OHIO DEPARTMENT OF TRANSPORTATION
CENTRAL OFFICE, 1980 W. BROAD ST., COLUMBUS, OHIO 43216-0899

Re: 2015 First Quarter Revisions

Revisions have been made to the ODOT Bridge Design Manual, January 2004. These revisions shall be implemented on all Department projects begin Stage 2 plan development date after January 16, 2015. Implementation of some or all of these revisions for projects further along the development process should be considered on a project-by-project basis.

Summary of Revisions to the January 2004 ODOT BDM

Figure 210

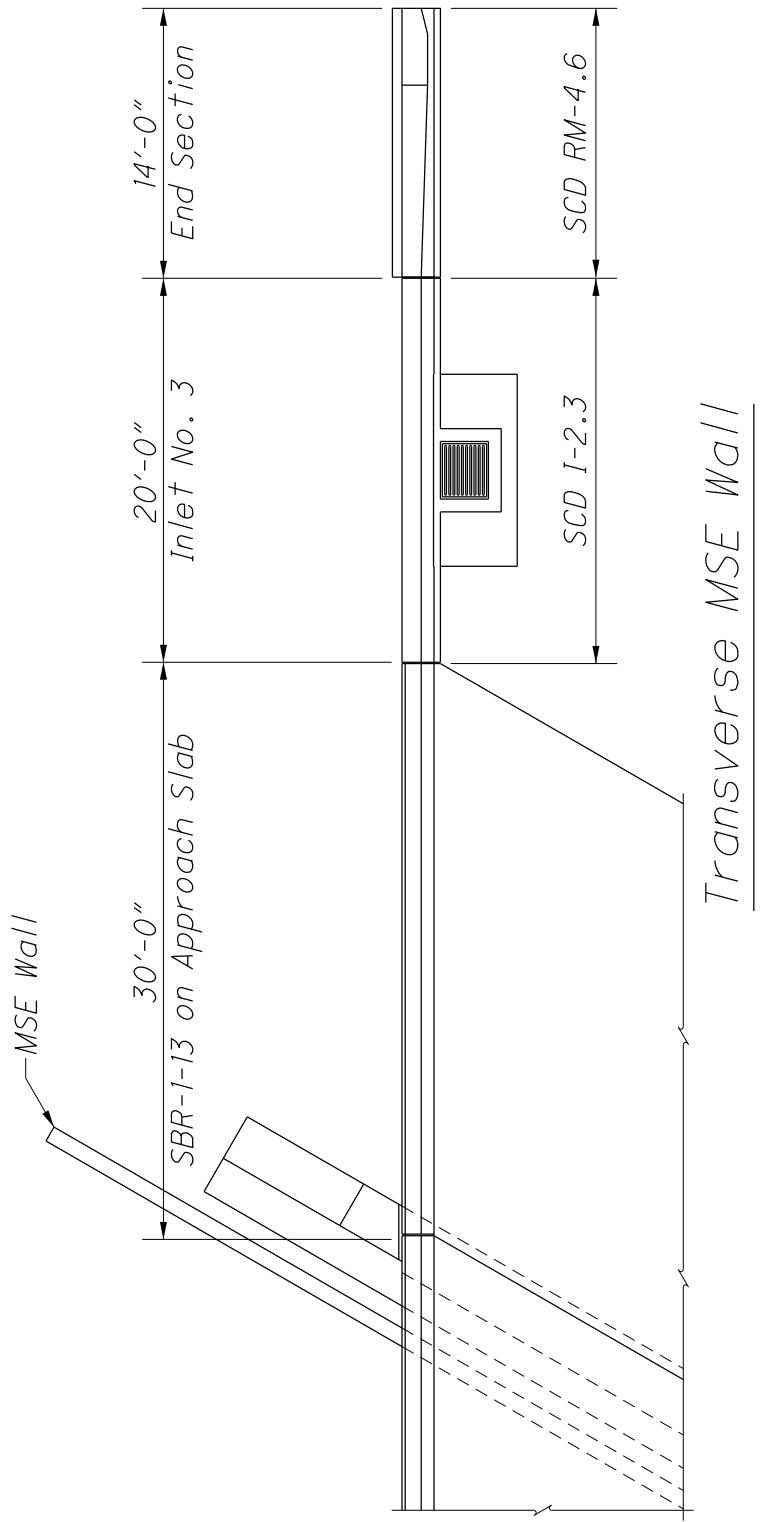
Control of drainage is especially critical at abutments with MSE walls. On structures with MSE walls at the abutments, a barrier shall be provided on the approach slab with a standard catch basin to collect the drainage. Where possible, the catch basin shall be located at least 25 ft beyond the limits of the MSE wall soil reinforcement. Continue the barrier 10 ft past the catch basin. Refer to BDM Figure 210 for more information.

Assumptions for TAEG Bracket Data Input

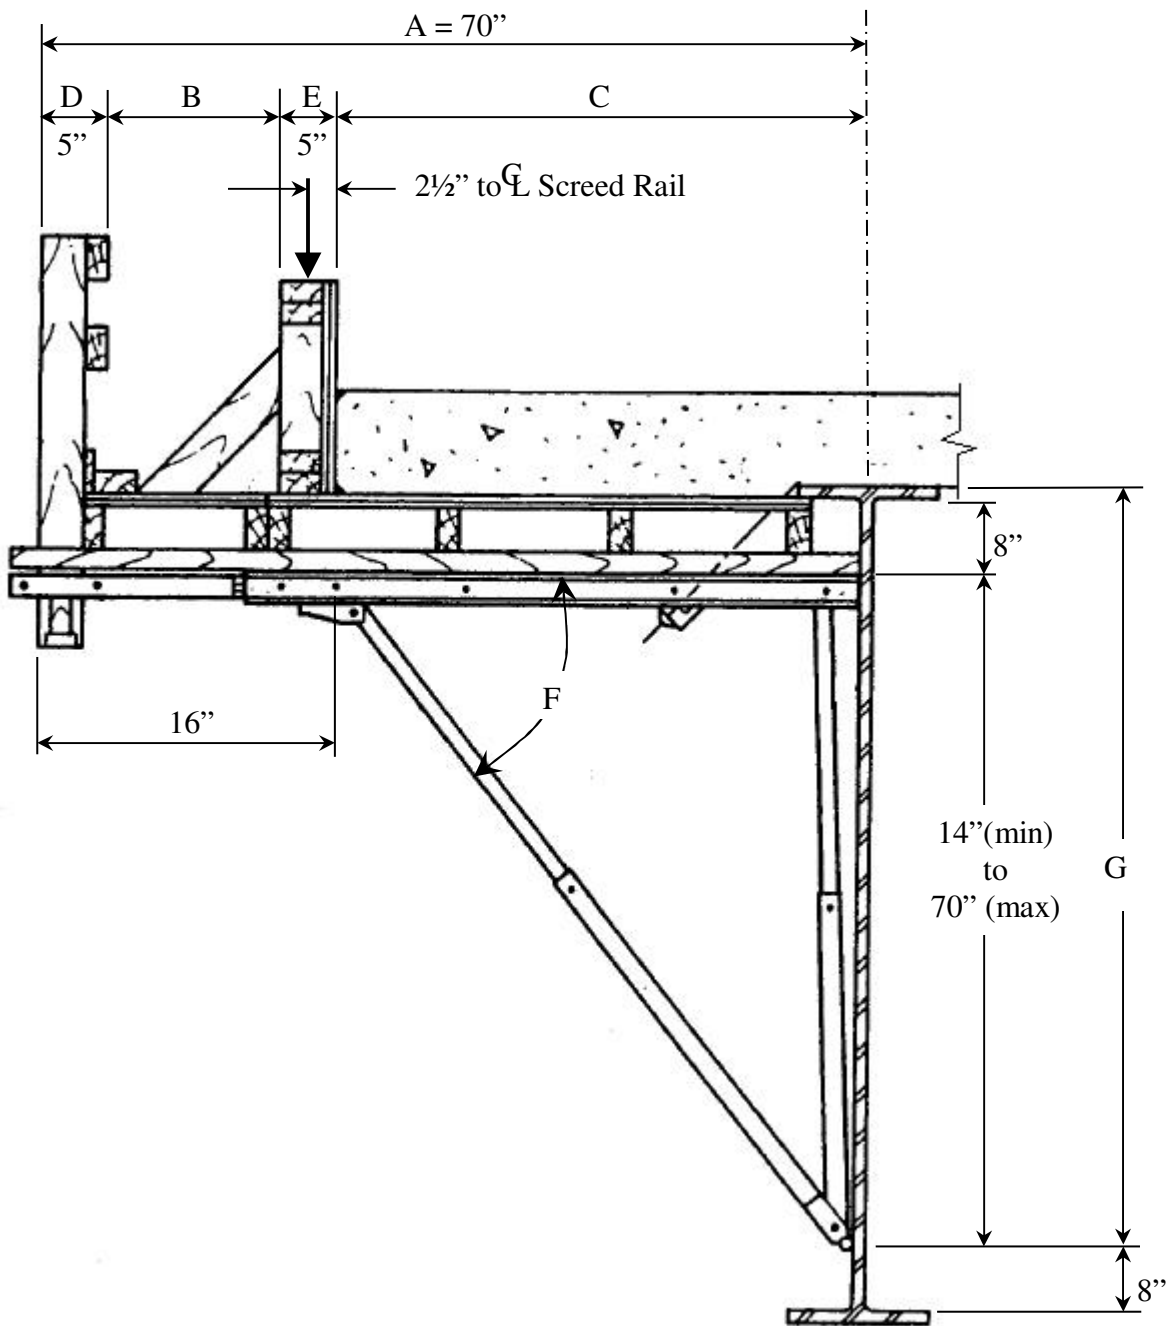
1. Refer to the following figure to determine TAEG dimensions A, B, C, D, E, F and G.
2. Designers may assume a center-to-center bracket spacing of 48.0 in.
3. Designers may assume a bracket weight of 50 lbs.
